DART SERVICE INSTRUCTION

TO AMEND INSTALLATION INSTRUCTIONS IIN-D130-701 REV. G AND INSTRUCTIONS FOR CONTINUED AIRWORTHINESS ICA-D130-701 REV.5 OR LATER APPROVED REVISION

The purpose of this Dart Service Instruction (DSI) is to authorize a series of deviations to facilitate the installation of a D130-701-043 basket and correct typographical errors found in IIN-D130-701 Rev. G.

FIGURE 1 - L/H AFT ANGLE ASSEMBLY

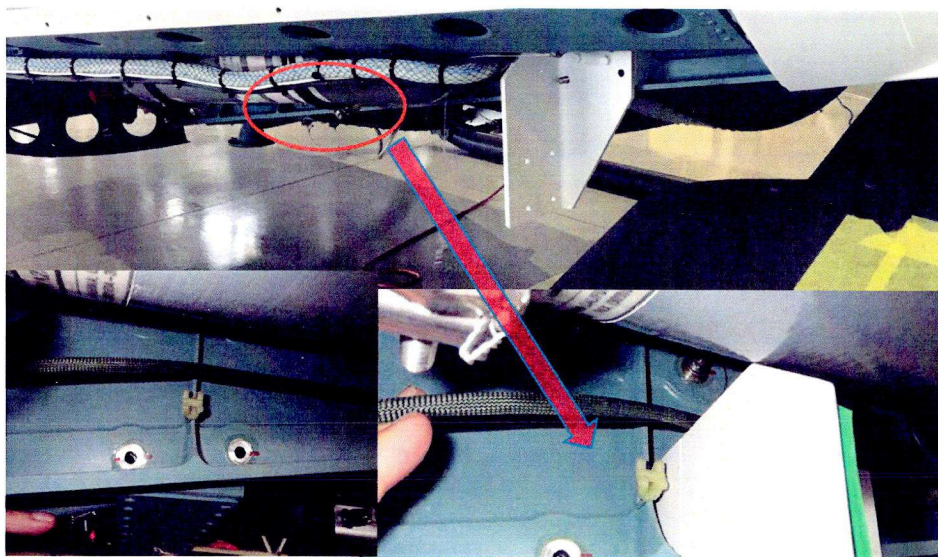
2.1. When installing L/H Aft Angle Assembly D4038-041, it interferes with a tie wrap mount.

Move the tie wrap mount shown below by 30mm - 40mm. Affix the tie wrap mount using CR3223-4, MS20426AD4, or equivalent fastener. Fill the existing rivet hole with MS20426AD4 or equivalent fastener.

FIGURE 2 - R/H AFT ANGLE ASSEMBLY INSTALLATION

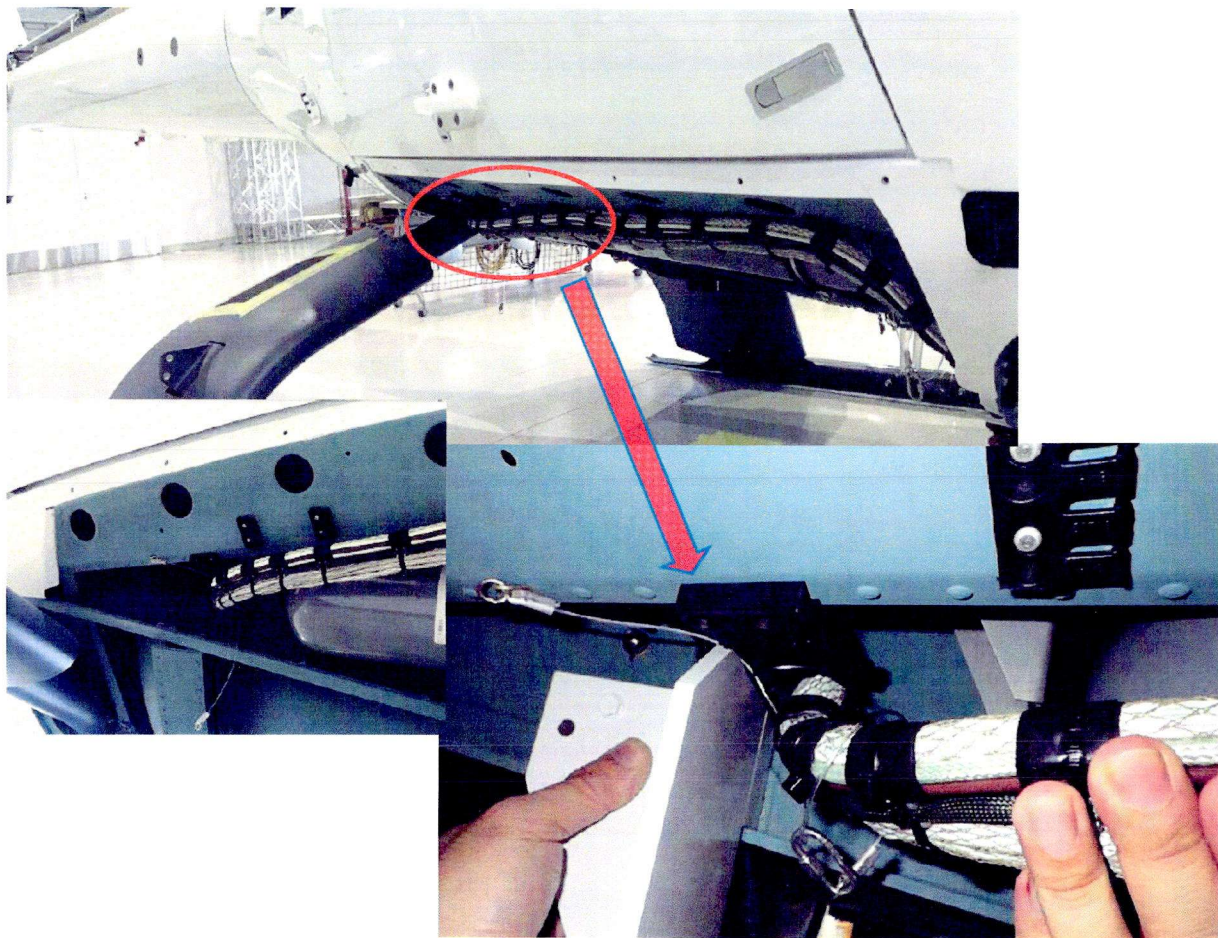
2.2. When installing the R/H Aft Angle Assembly D4038-044, it interferes with the existing wiring.

Change the wire routing according to the Aircraft Maintenance Manual or change the position of the tie wrap mount using CR3223-4, MS20426AD4, or equivalent fastener and tie wraps per the Aircraft Maintenance Manual.

FIGURE 3 - ADJUSTING R/H AFT ANGLE ASSEMBLY

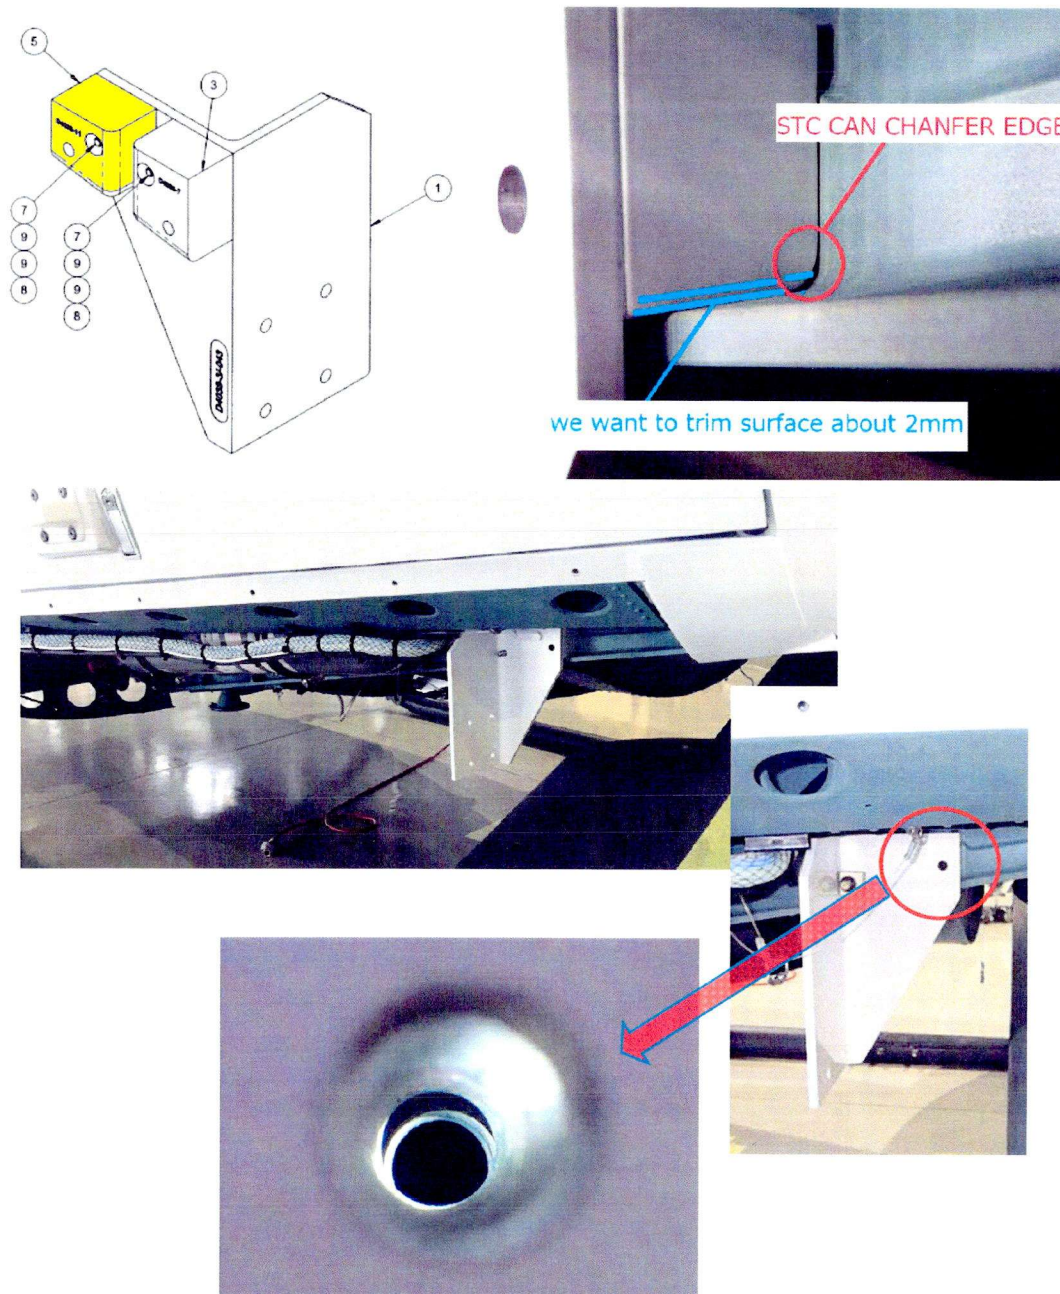
2.3. When installing the L/H and R/H Aft Angle Assemblies D4038-043/-044, they do not sit flush against the bracket wall, as shown in the pictures below.

Trim the bottom of the block shown in yellow below by approximately 2mm. Alternatively, the offending edge may be chamfered to ensure a flush fit.

FIGURE 4 - FORWARD CROSSBEAM INSTALLATION

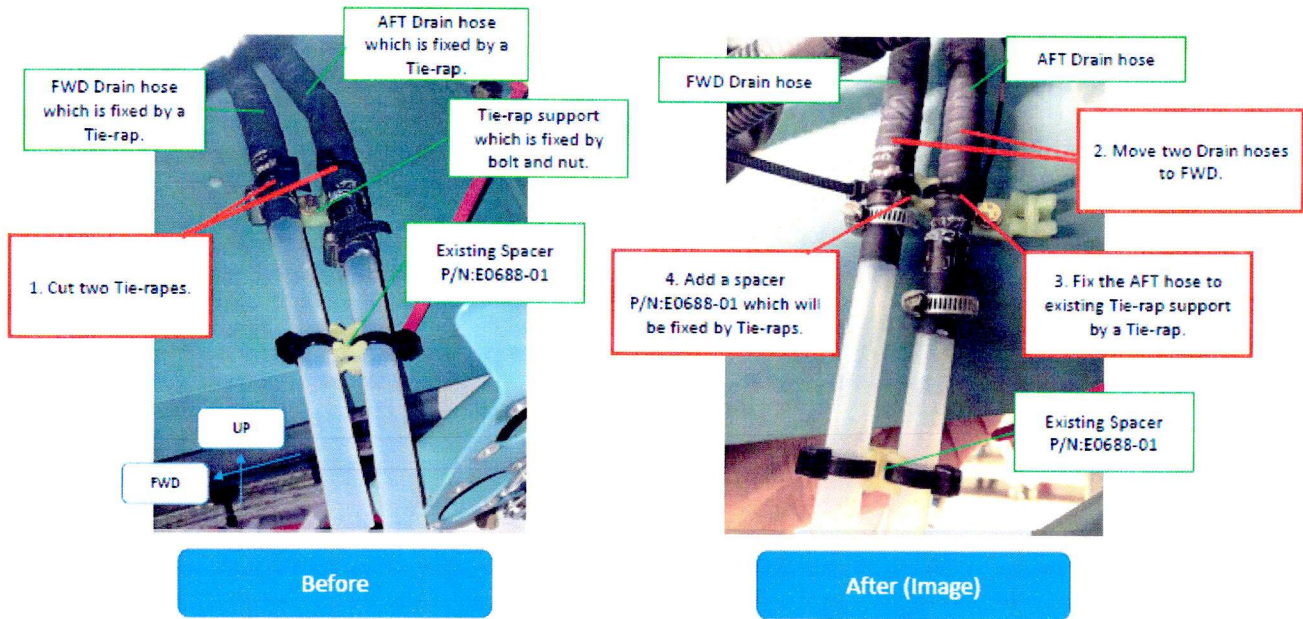
2.4. When installing the D4037-3 Forward Crossbeam to the aircraft, along with the existing Cargo Hook connector bracket, it interferes with two existing drain hoses.

Cut the two tie wraps holding the drain hoses in place. Move the two drain hoses forward to prevent interference with the D4037-3 Fwd Crossbeam. Fix the aft hose to the existing tie wrap support with a tie wrap. Add a spacer P/N E0688-01 in between the two drain hoses. Fix the hoses together using tie wraps as shown in Figure 4 below.

FIGURE 6 - CARGO HOOK CONNECTOR BRACKET

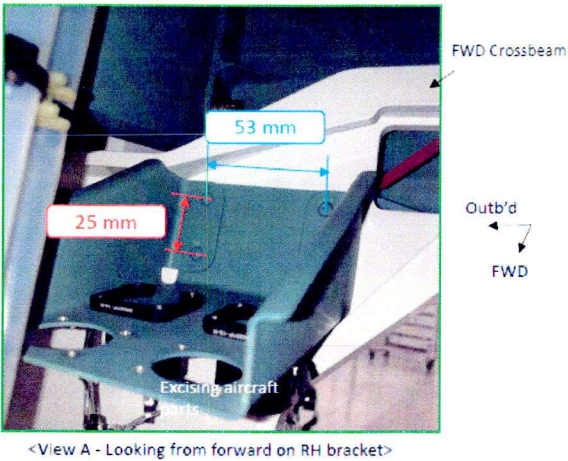
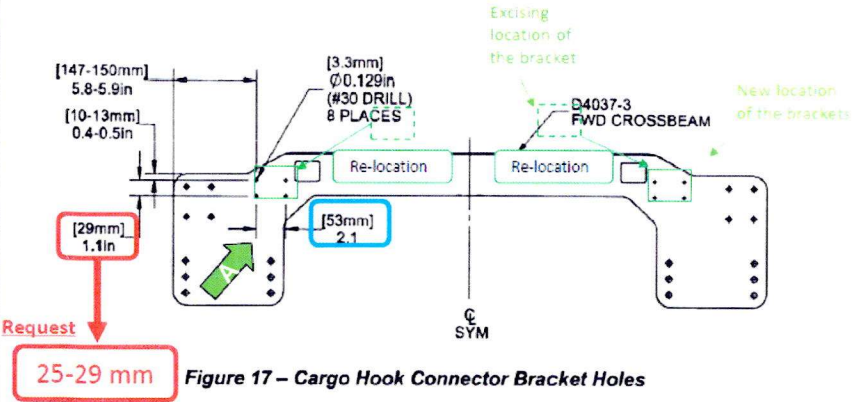
2.6. When installing the Cargo Hook Connector Bracket, the holes (outlined in red below) were drilled with a pitch of 25mm, instead of 29mm.

It is acceptable to install the bracket using holes drilled with a 25 mm pitch instead of a 29 mm pitch.

FIGURE 7 - CARGO HOOK CONNECTOR BRACKET LOCATION

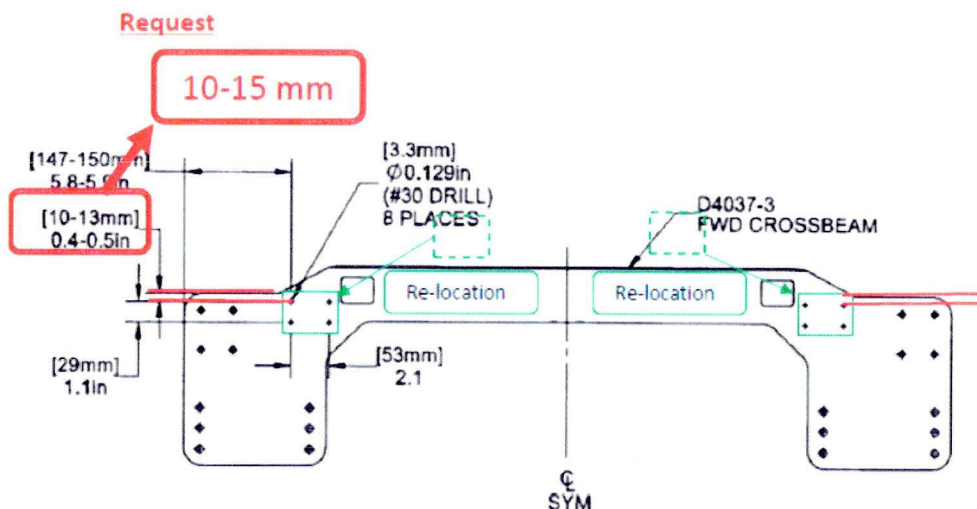
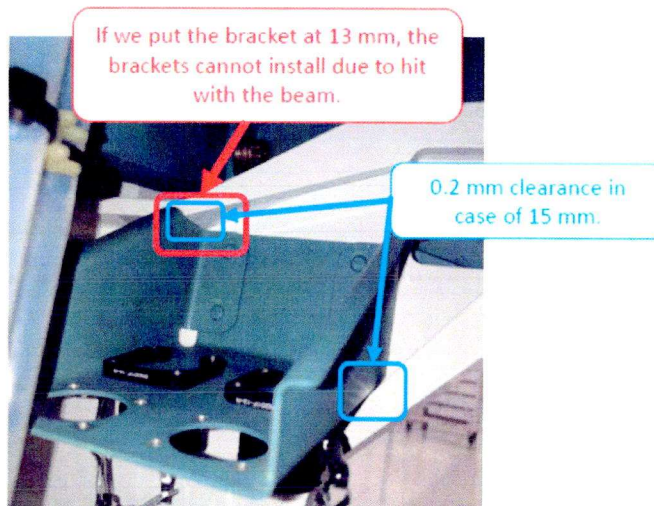
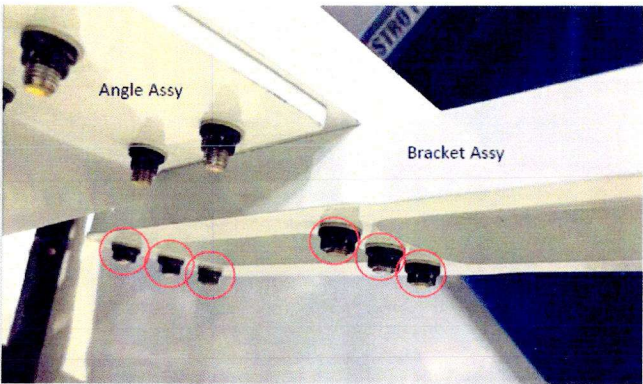
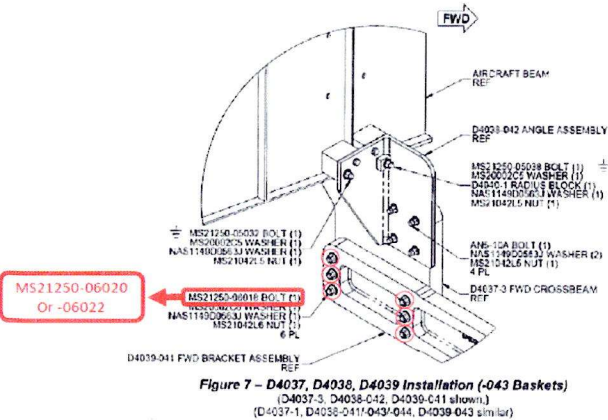
2.7. Due to interference between the brackets and the cargo beam, the connector brackets are located 15 mm from the upper face of the beam, instead of 10-13 mm.

It is acceptable to install the connector bracket 15 mm from the upper face of the beam instead of 10-13 mm from the upper face of the beam. When the basket(s) are removed from aircraft, it is acceptable to leave the D4037-1/-3 crossbeams installed as part of the D130-701-013 fixed provisions kits.

FIGURE 8 - BOLT LENGTH ON D4039-041 AND D4039-043 BRACKET ASSEMBLIES

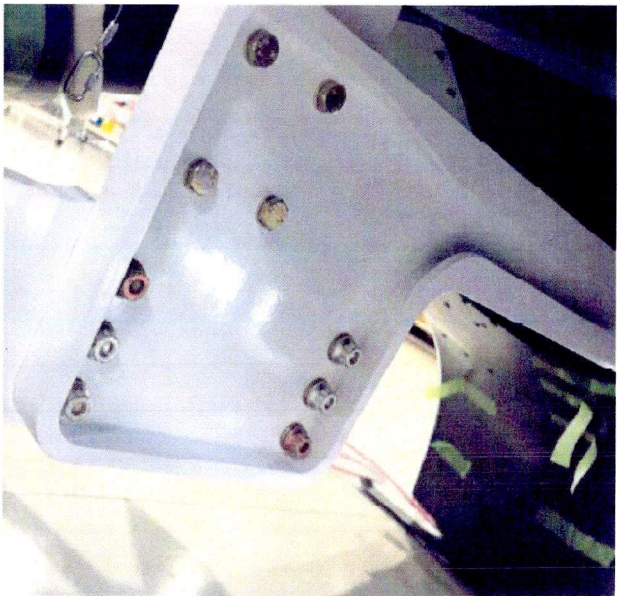
2.8.The attachment bolts, P/N MS21250-06018, used for attaching the D4039-041 Fwd Bracket Assembly to the D4037-3 Fwd Crossbeam and the D4039-043 Aft Bracket Assembly to the D4037-1 Aft Crossbeam per IIN-D130-701 paragraph 3.2.17 are too short. Only one thread shows when fully tightened.

It is acceptable to replace the MS21250-06018 bolts with MS21250-06020 bolts (24 qty total) to ensure sufficient threads in safety.

FIGURE 9 - MODIFICATION TO D4039-041/-043 BRACKET ASSEMBLIES

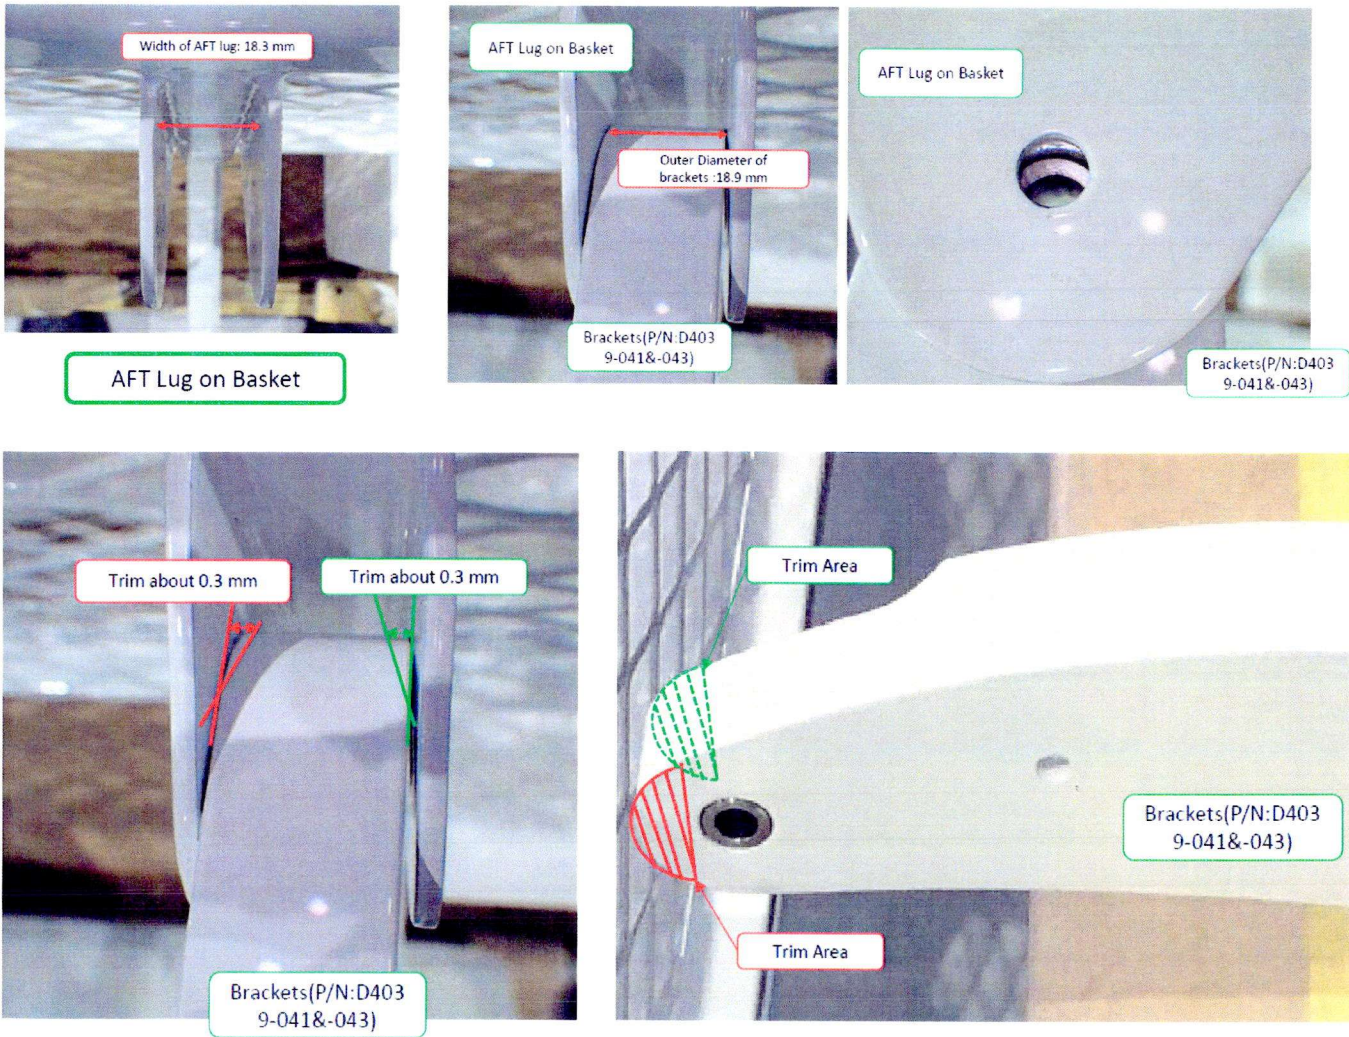
2.9.The D4039-041 forward and D4039-043 aft bracket assemblies are too wide to completely fit into the upper mounting lugs on the basket assembly. This results in the mounting holes not aligning properly.

It is acceptable to trim the upper lugs on the D4039-041 and D4039-043 bracket assemblies by approximately 0.3 mm on each side, to ensure a proper fit into the mounting lugs on the basket. After trimming, touch up the trimmed portion with Alodine 1200/1201 as per MIL-C-5541. Prime the parts as required per the Aircraft Maintenance Manual prior to installation.

FIGURE 10 - MISALIGNMENT ISSUE

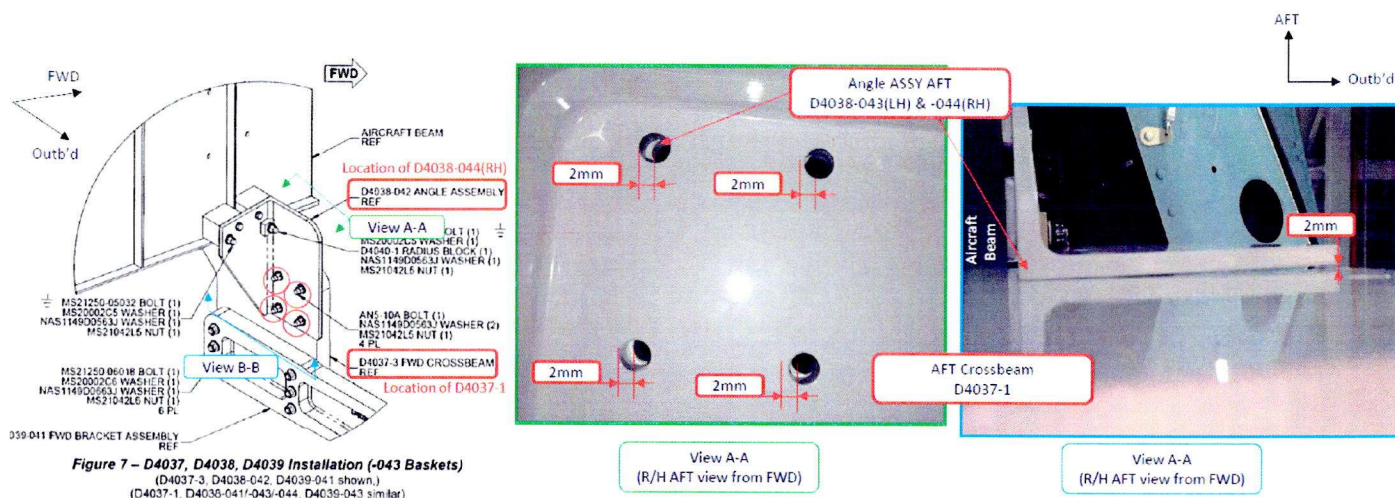
2.10. There is approximately a 2 mm misalignment of the attachment holes between the D4037-1 aft crossbeam and the D4038-043 and D4038-044 Aft Angle Assemblies.

It is acceptable to add "0.040" and "0.032" thick aluminum shims as shown in Figure 10/11. The existing attachment bolts do not need to be changed. In reference to Figure 11 of this service instruction, add shims as follows:
